A G E N D A

Architectural Review Board

May 22, 2018

2424/2426 Agnew Street

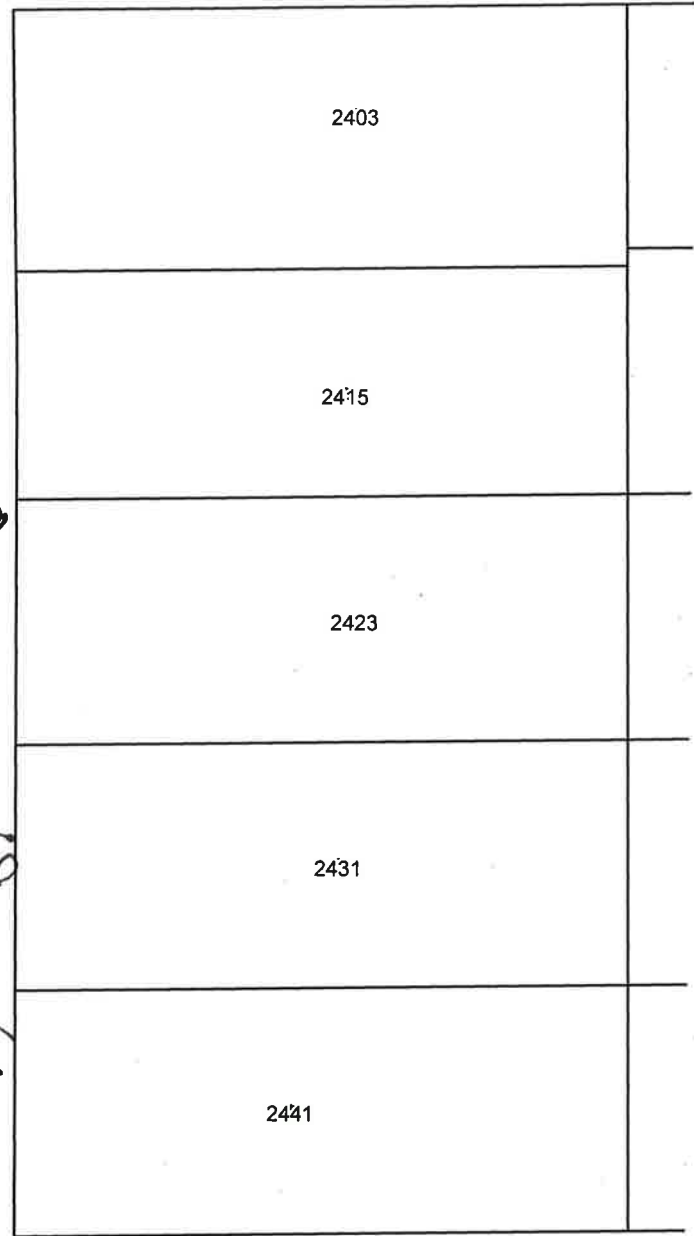
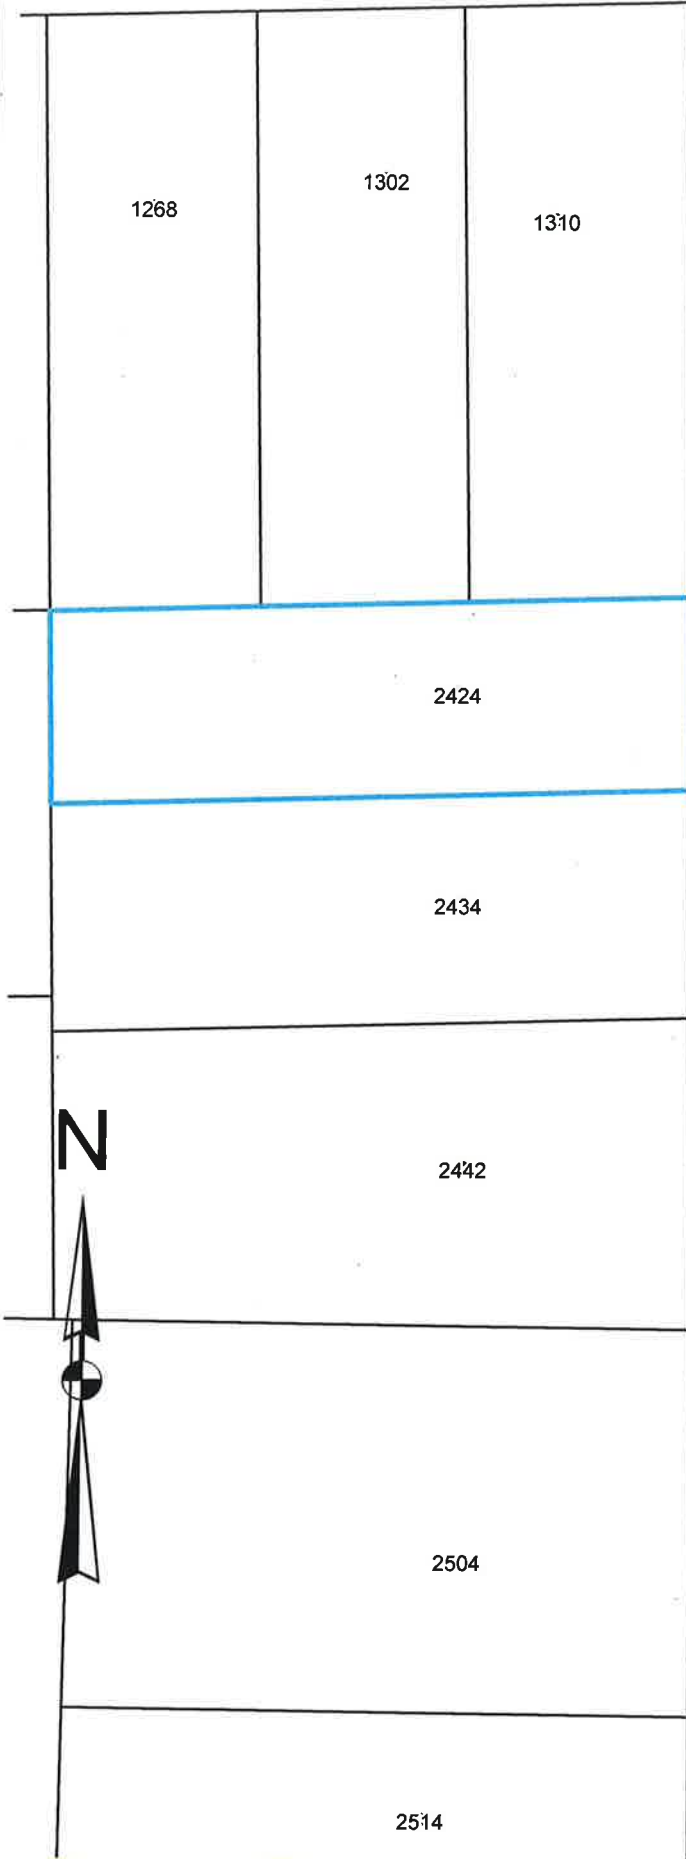
- Most of the options introduce paving to more than 50% of the front yard. The Board has generally required vegetative screens to help soften the appearance of parking surfaces from the streetscape view. Staff has also advised petitioners in the past that the ratio of pavement to grass in front yards was important to avoid this:

4 South Capitol Parkway

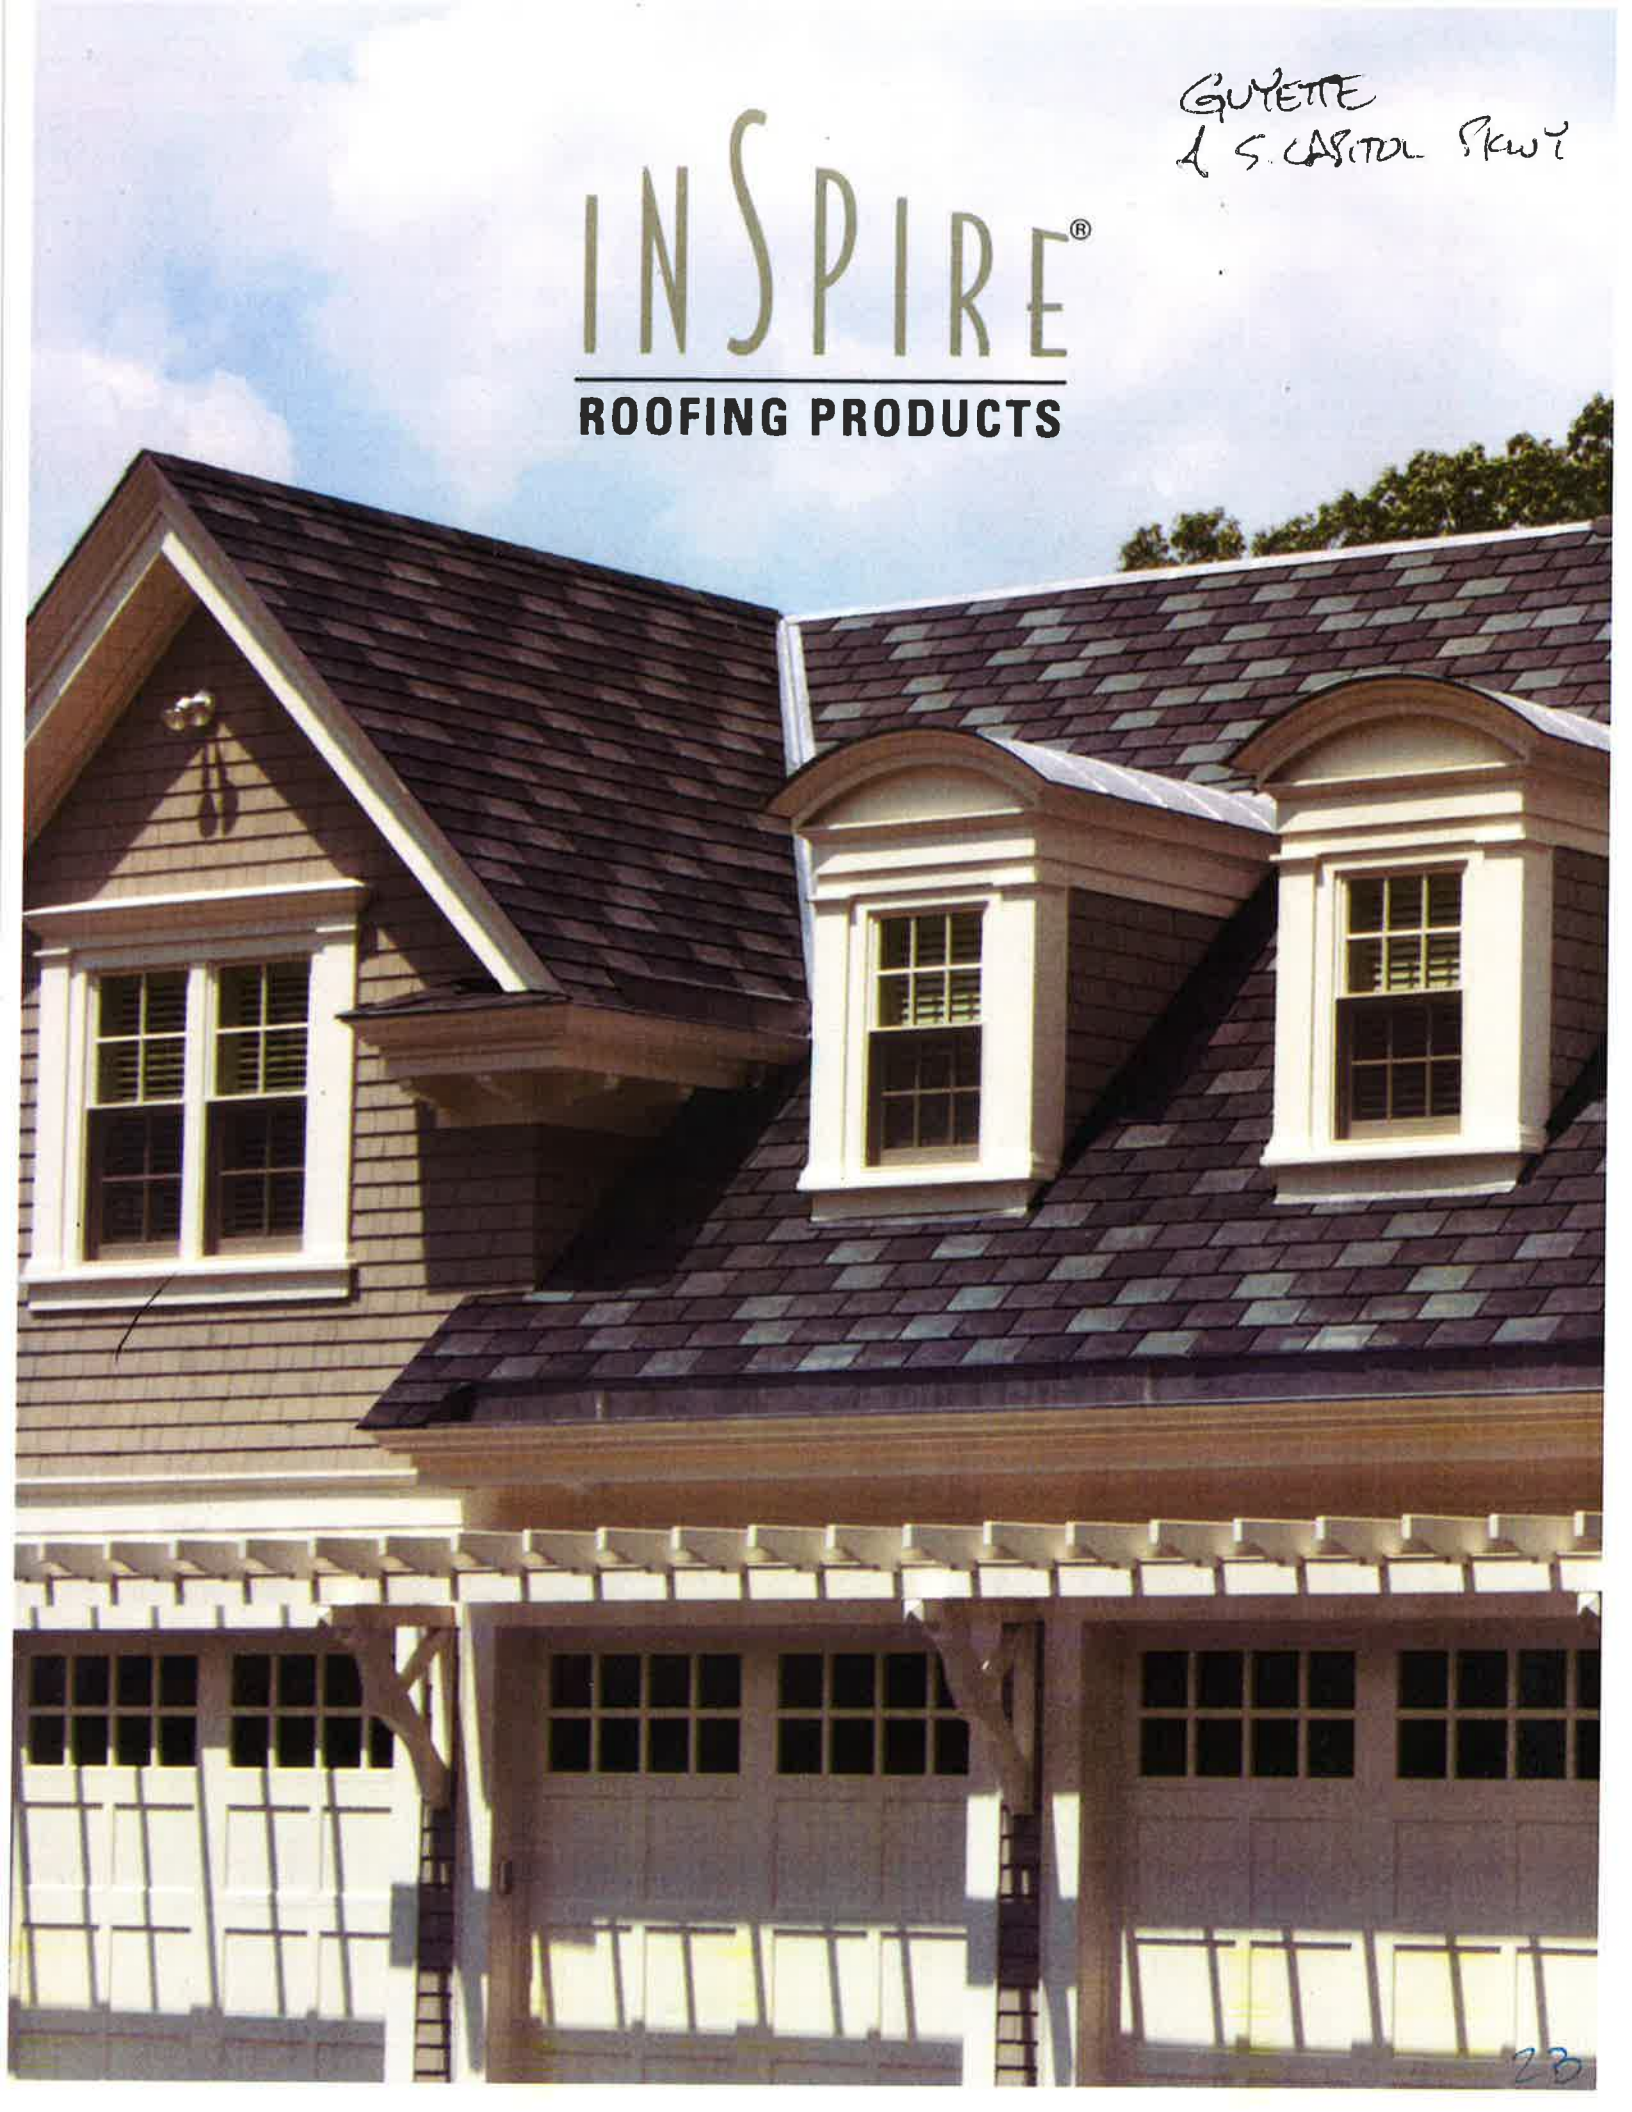
- No objection.

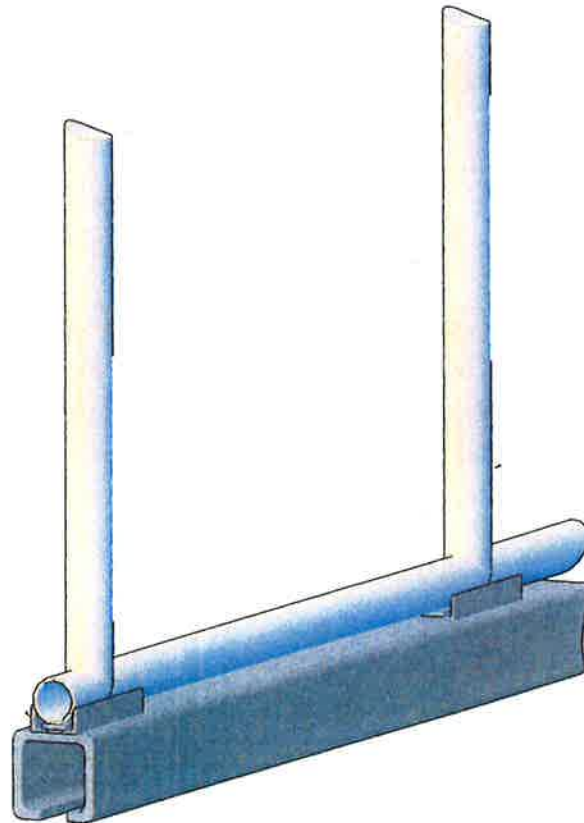
steel channel support
assembly welded below
each gate frame vertical

existing gate frame

new cantilever
rail

5E

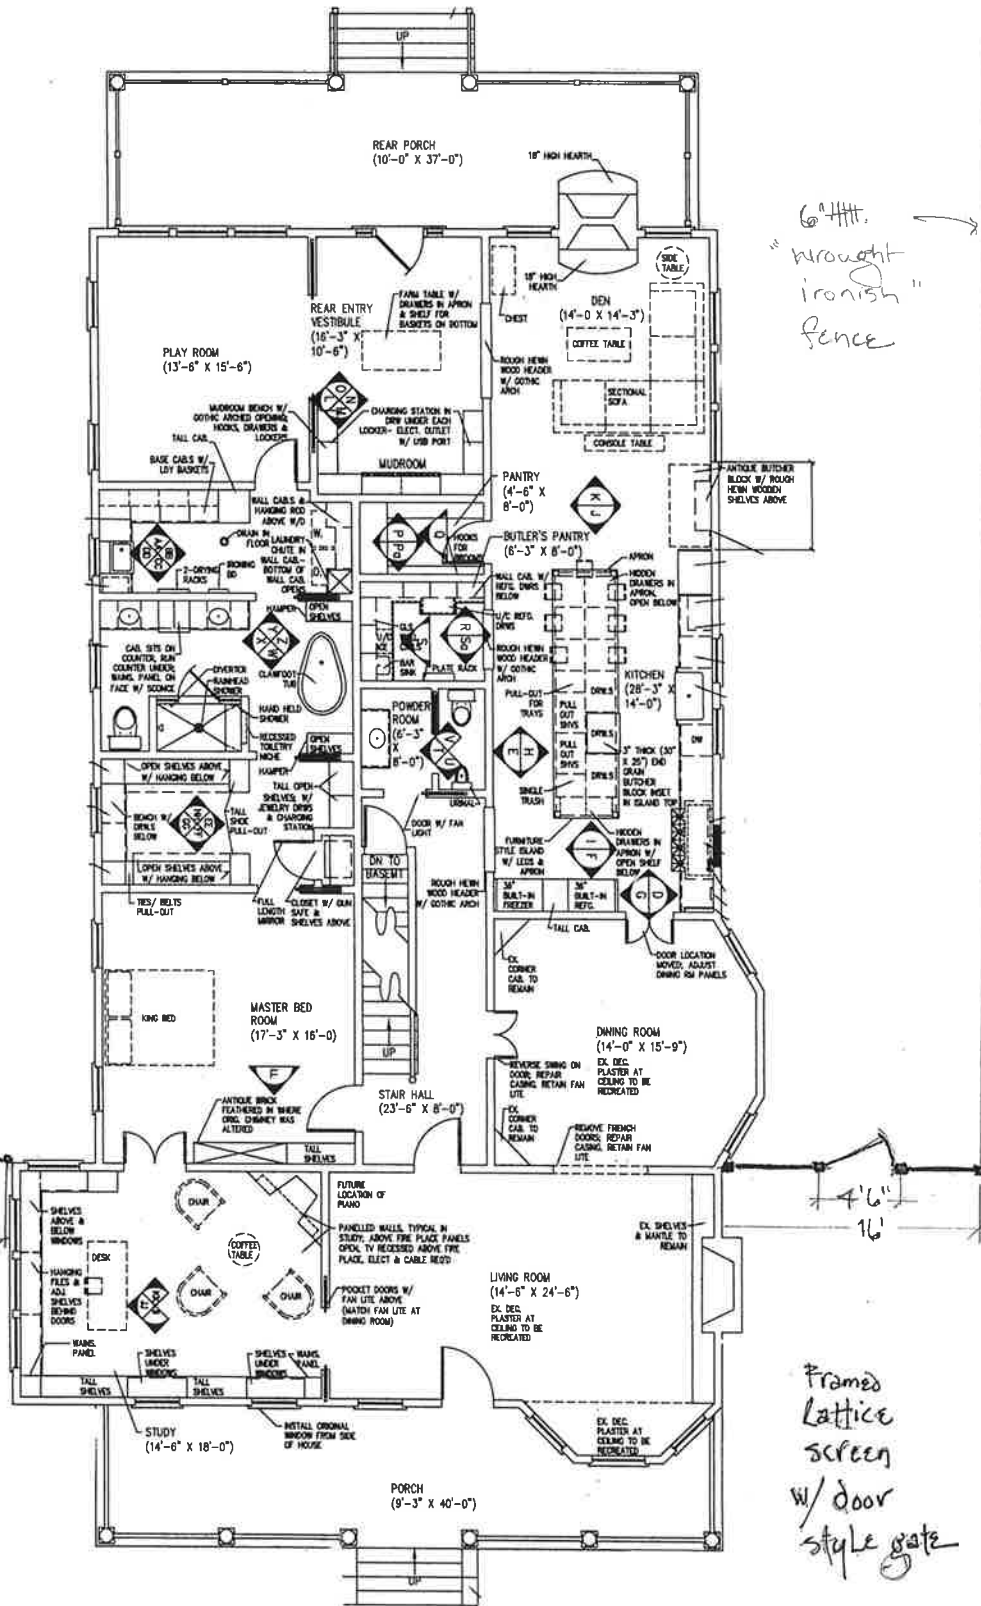
- Typically the Board has requested screening of front yard paving material to soften the appearance of additional parking areas. The plan provides a continuous screen of evergreen material.
- There are two other circular drives on that block and side of street, at 766 Felder and 782 Felder.
- Tree replacement meets the requirements for the replacement of removed trees to accommodate the construction phase of this project.
